Asset I dentifier	PHAU04280501
Address	VAUGHAN HOUSE, 1-51,NELSON SQUARE,NELSON SQUARE GARDEN ESTATE,BOROUGH & BANKSIDE
Post Code	SE1 OPY

Code	FRA-PB
Version	4
Description	FRA-PURPOSE BUILT BLOCKS

Assessment Ref	PHAU04280501-FRA-PB-4-20170712-110502	
Assessment Date	12/07/2017	
Assessment Type	Latest Results	
Assessor Name	Herpal Chahal

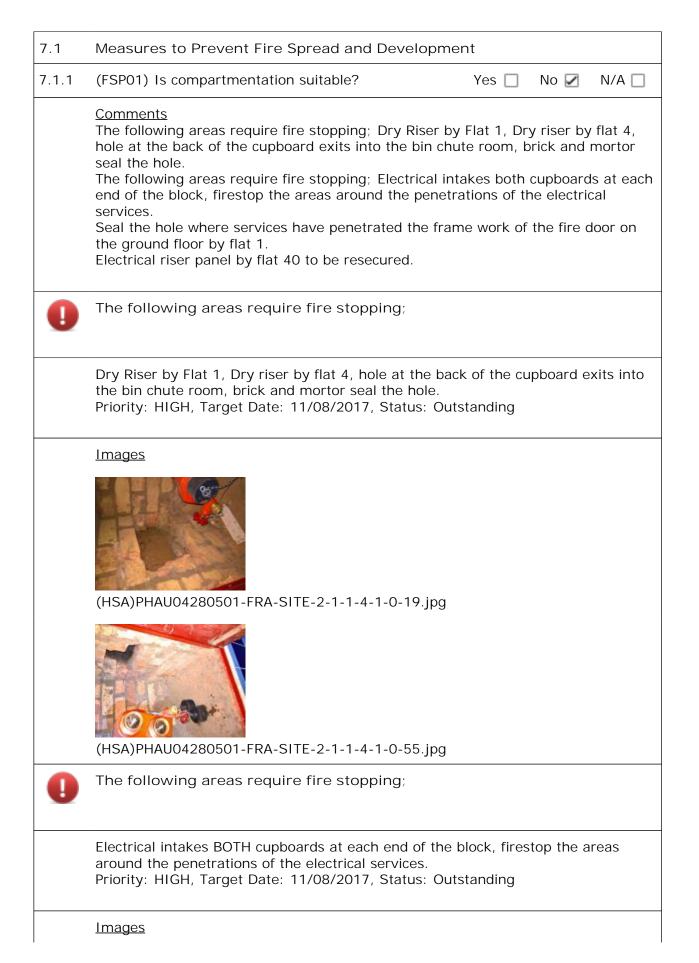
Hole between the frame and wall of the fire door.

Seal the hole where services have penetrated the frame work of the fire door on the ground floor by flat 1. Priority: HIGH, Target Date: 11/08/2017, Status: Outstanding
